## Proposal to Introduce a Temperature Correction for the Tyre Rolling Sound Component of Pass-by Tests according UN Regulation No. 51.03 Annex 3

The text below has been prepared by the experts of the Informal Working group on Measurement Uncertainties (IWG MU) in order to introduce measures to reduce variability. The modifications to the existing text of the UN regulation are marked in **bold** for new or ~~strikethrough~~ for deleted characters. Some modifications include moving existing provisions to other places.

Figure 5a Flowchart for vehicles tested according to paragraph 3.1.2.1. of Annex 3 to this Regulation – Correction of pass-by measurements for temperature and if applicable for test track differences

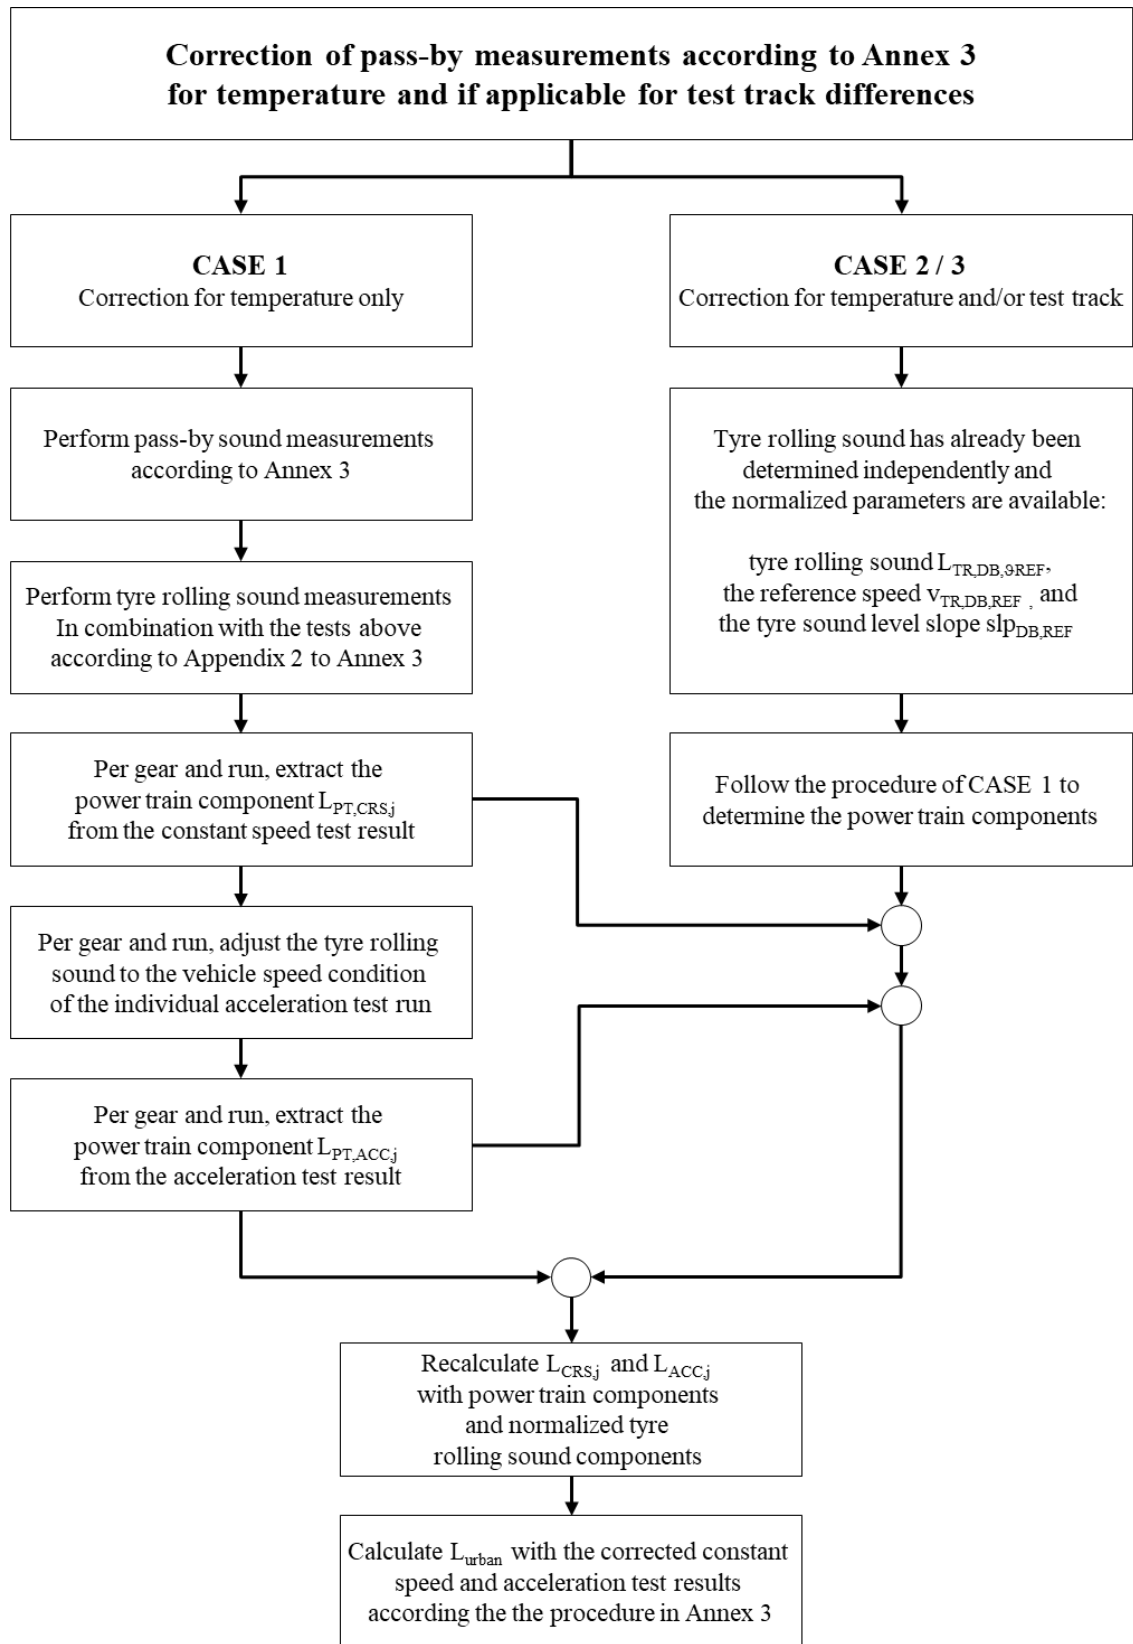
1. General (see the flowchart in Appendix 3, Figure 5a to Figure 5d)

The formula for temperature correction is applicable to C1 tyres only. In case a vehicle is equipped with C2 tyres, the temperature correction is not applied (CASE 3 described in paragraph 4. of this appendix).

4. **CASE 3:**  
Case 3 is applicable for C2 tyres only and provides a correction for different test tracks without any temperature correction applied.

**Figure 5b** Flowchart for vehicles tested according to paragraph 3.1.2.1. of Annex 3 to this Regulation – Temperature Correction for Tyre Rolling Sound Components CASE 1

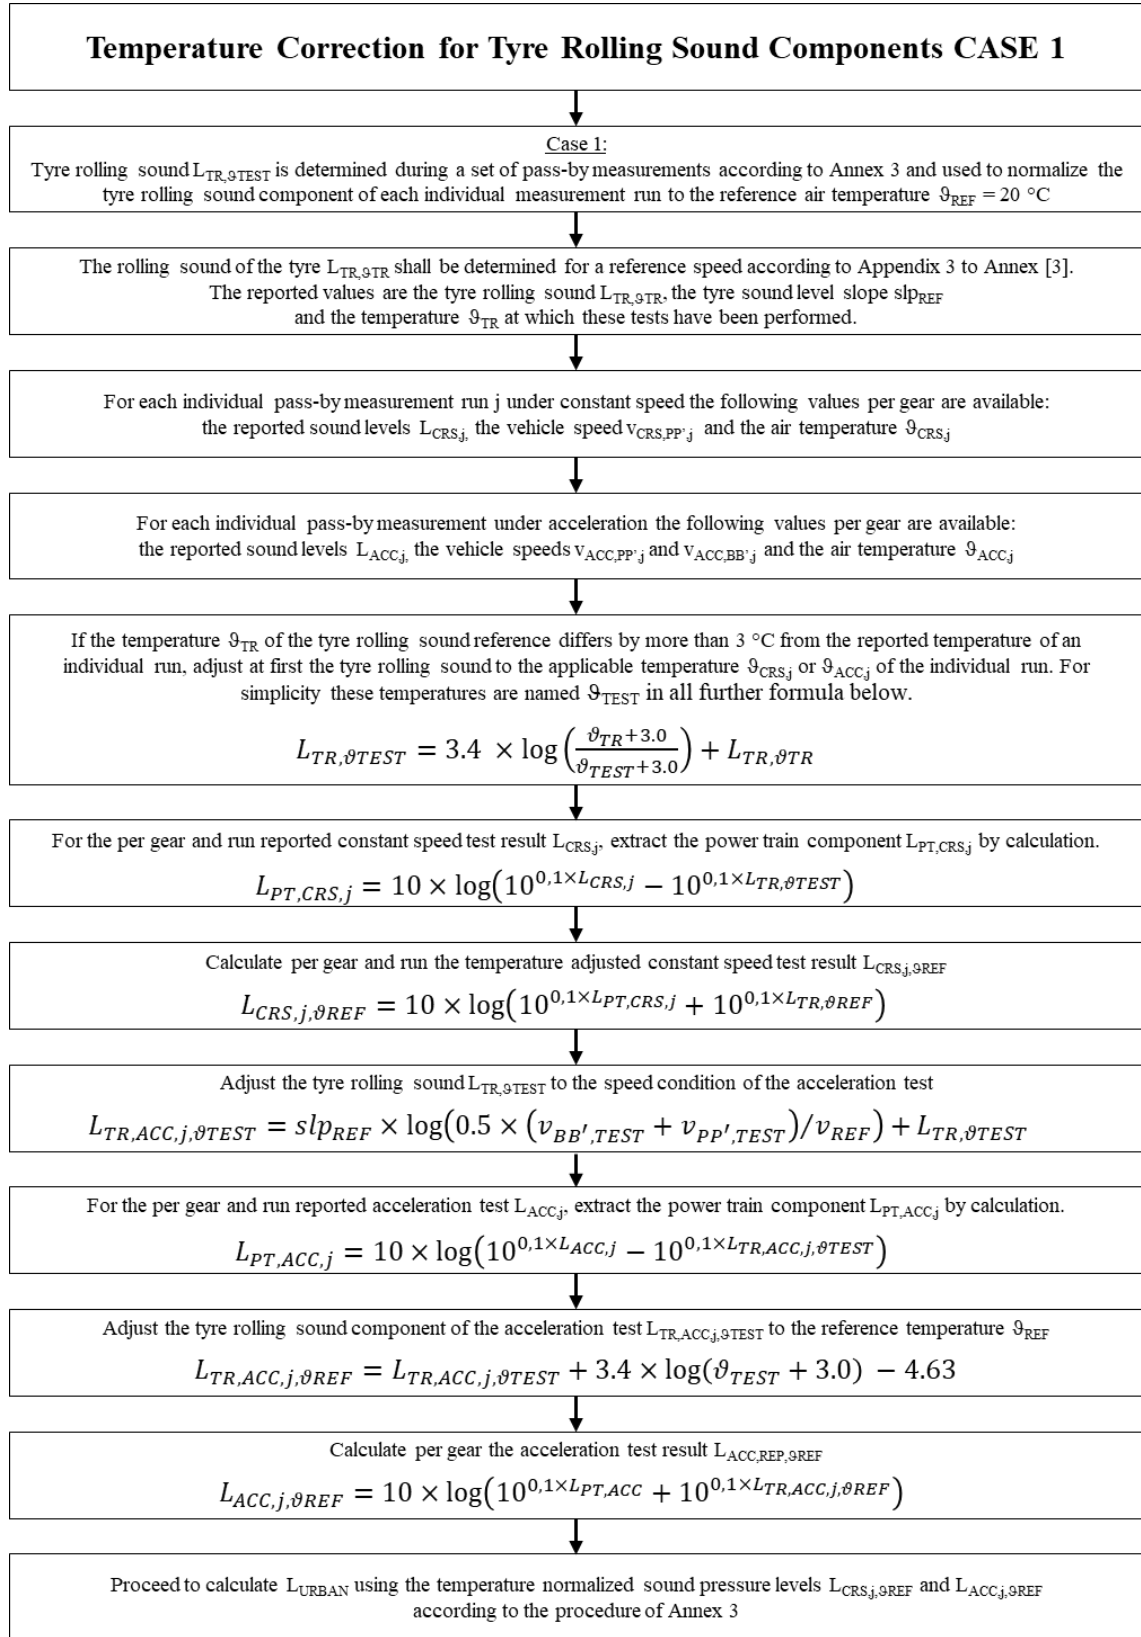
2. **CASE 1:**  
The temperature correction is based on tyre rolling sound measurements carried in junction with pass-by tests according to Annex 3.
- 2.1. The rolling sound of the tyre  $L_{TR,\theta TR}$  shall be determined for a reference speed according to Appendix 3 to Annex 3.
- 2.1.1. The reported values are the tyre rolling sound  $L_{TR,\theta TR}$  at the reference speed  $v_{TR,REF}$ , tyre sound level slope  $slp_{TR}$  and the air temperature  $\theta_{TR}$  at which these tests have been performed.

- 2.1.3. If the temperature  $\theta_{TR}$  of the tyre rolling sound reference differs by more than 3 °C from the reported temperature of an individual run, adjust at first the tyre rolling sound to the applicable air temperature  $\theta_{CRS,j}$  or  $\theta_{ACC,j}$  of the individual run. For simplicity these individual temperatures per test run are named  $\theta_{TEST}$  in all subsequent calculation formula.

**Figure 5c** Flowchart for vehicles tested according to paragraph 3.1.2.1. of Annex 3 to this Regulation – Temperature Correction for Tyre Rolling Sound Components CASE 2

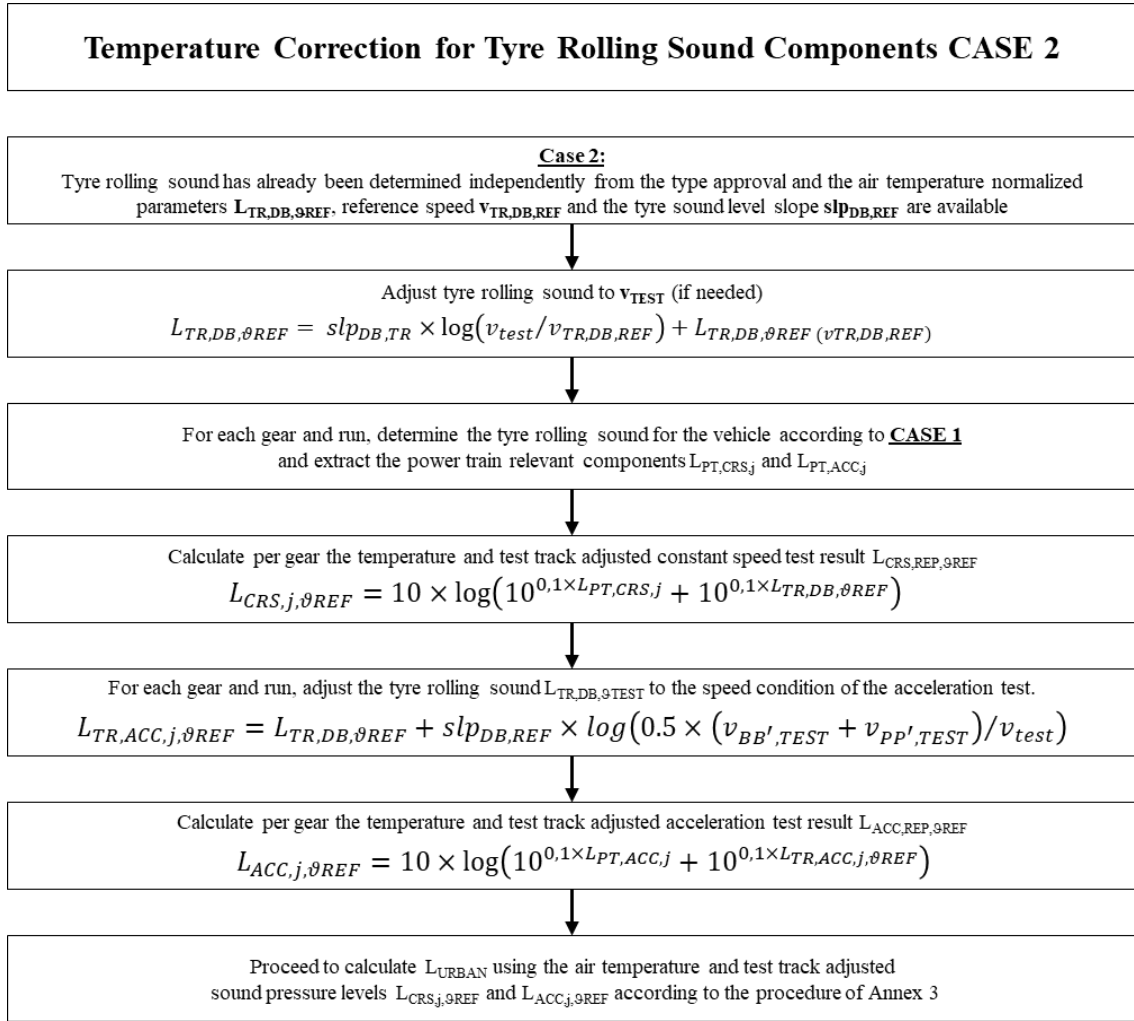
3. **CASE 2:**  
The temperature correction based on tyre rolling sound measurements that have been performed independent from the pass-by tests subject to the temperature correction.

Case 2 is applicable, when pass-by tests carried out according to Annex 3 shall be compared with already existing results – e.g. from type approval, that have been performed under a different temperature condition and on a different test track.

**Figure 5d** Flowchart for vehicles tested according to paragraph 3.1.2.1. of Annex 3 to this Regulation – Test Track Correction for Tyre Rolling Sound Components CASE 3

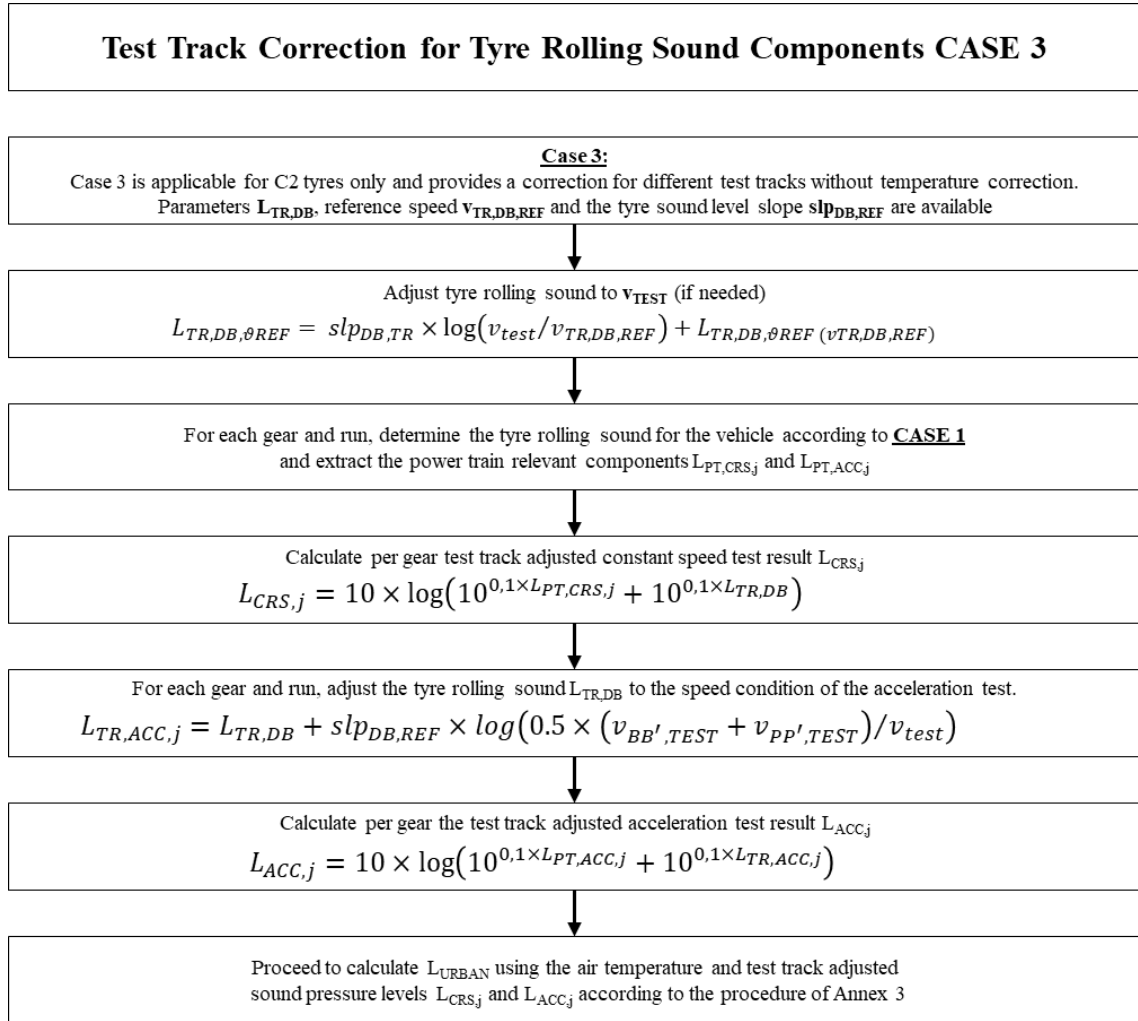
A temperature correction is not applicable, but scheme to determine the tyre rolling sound in combination with Annex 3 tests and the extraction of the power train sound components remains valid.

Figure 6a: Measurements of air and track surface temperature (about 700 measurement points under various ambient conditions (summer, winter, cloudy, sunny, etc...))

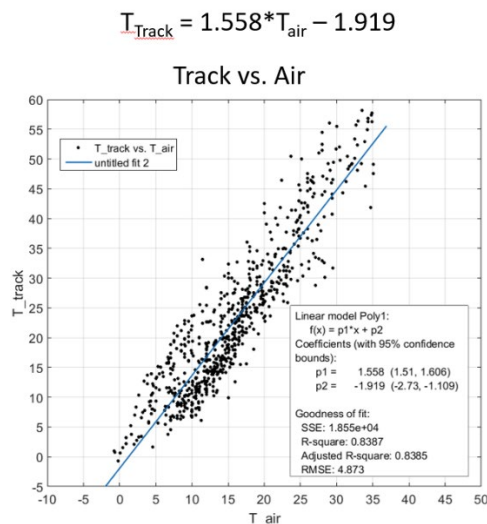
6. Addition of new appendix to describe the correction for temperature and test track dependent on the tyre category and purpose. Therefore, three different cases are described:
  - 1) Tyre rolling sound measurements carried in junction with pass-by tests according to Annex 3
  - 2) Tyre rolling sound measurements that have been performed independent from the pass-by tests subject to the temperature correction
  - 3) Tyre rolling sound measurements for C2 tyres only for correction of different test tracks without temperature correction.
7. Since air temperature is more stable than track temperature due to weather conditions the correction is based on air temperature.

8. The tyre rolling sound component will be corrected to a reference air temperature. Thus, the temperature range is less critical as today.

Figure 6b: Temperature Correction for Tyre Rolling Sound Component

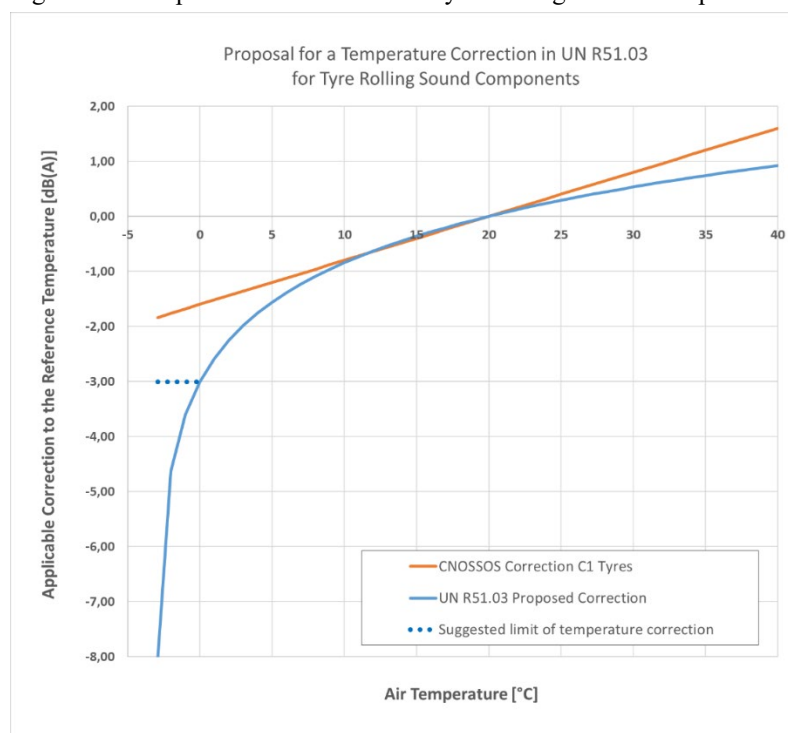
The UN Reg. No. 51.03 temperature correction is a logarithmic function to address the extreme temperature situations at very low and very high temperatures WITHIN THE SPECIFIED TEMPERATURE RANGE more adequate relative to linear functions (In the diagram below the CNOSSOS applied correction is shown).

However, at air temperatures below 5°C, the correction is very much based on the chosen logarithmic function. Especially normal (summer) tyres change their rolling sound performance very fast (becoming louder) due to the change of the physical behaviour of the rubber compound. This effect starts typically below 7°C. Therefore, in many countries it is suggested to not use summer tyres at cold temperatures. After a tyre has changed its compound properties, the characteristics become stable again, so that the tyre does not become significant more loud at further reduced temperatures. It is suggested to limit the correction function to an air temperature of 0 °C. This means, when tests are carried out at air temperatures below 0°C, the correction is based on 0°C.

The maximum applicable correction is limited to 3 dB(A). This is in line with typical observation on tyre rolling sound for tyres at very cold temperatures.
